Microcontroller Technical Information

QB-78K0RKX3 In-Circuit Emulator for 78K0R/KE3, 78K0R/KF3, 78K0R/KG3, 78K0R/KH3, 78K0R/KJ3 Usage Restrictions	Document No.	ZBG-CD-08-0022	1/2								
	Date issued	June 5, 2008									
	Issued by	Development Tool Solution Group Multipurpose Microcomputer Systems Division Microcomputer Operations Unit NEC Electronics Corporation									
Related documents	QB-78K0RKX3 User's Manual: U17866EJ4V0UM00 QB-78K0RKX3 (Control Code: E, F, G, H, J, K, L, M) Operating Precautions: ZUD-CD-08-0072	Notification classification

Operating Precautions for QB-78K0RKX3

No. 11 Restriction whereby invalid operations occur if there is a ROM instruction several instructions before an instruction for which a “break before execution” is set

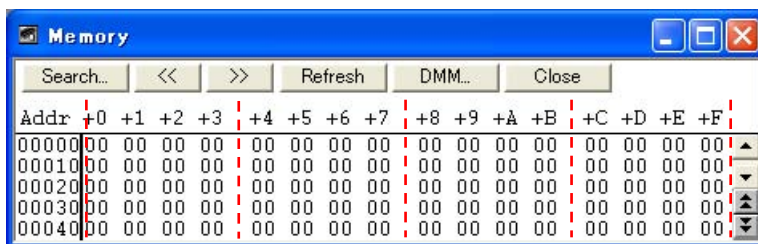
If there is an instruction to read the ROM area several instructions before an instruction for which a “break before execution” is set (up to nine instructions in case of an 8-bit instruction), the break may not occur, or the program may not operate correctly.

If the instruction subject to the break does not extend over a 4-byte boundary^{Note}, the instruction is not replaced and the break does not occur.

If the instruction subject to the break extends over a 4-byte boundary^{Note}, only the code immediately before the boundary is replaced. As a result, the instruction becomes invalid and may loop.

Note The 4-byte boundaries are portions shown as red dotted lines in the following figure.

There is no workaround.

This issue has been corrected in products with control code K and later.

No. 16 Restriction on program execution on RAM

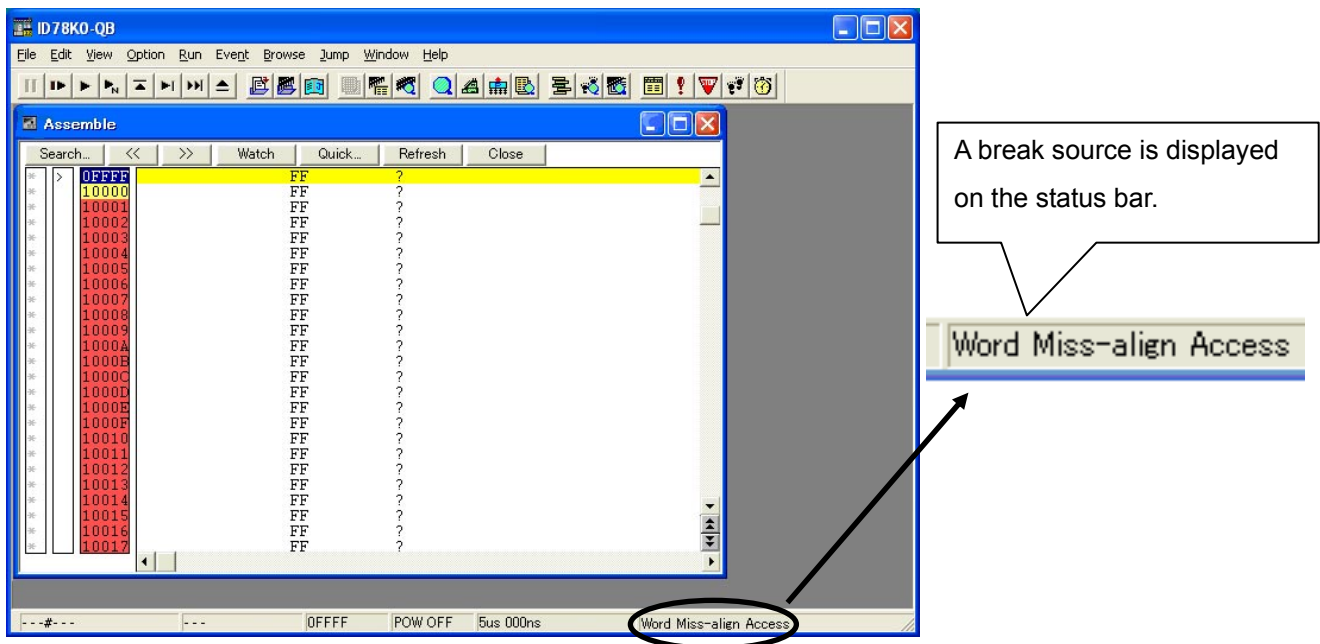
When a branch instruction is executed on RAM and if the branch destination is an odd address located in RAM, a fail-safe break due to a word misalign access occurs.

A break source can be checked in the status bar in the ID78K0R-QB, as shown below.

Clear the check box for the [Word Miss-align Access] in the Fail-Safe Break dialog box in the ID78K0R-QB.

This issue has been corrected in products with control code M and later.
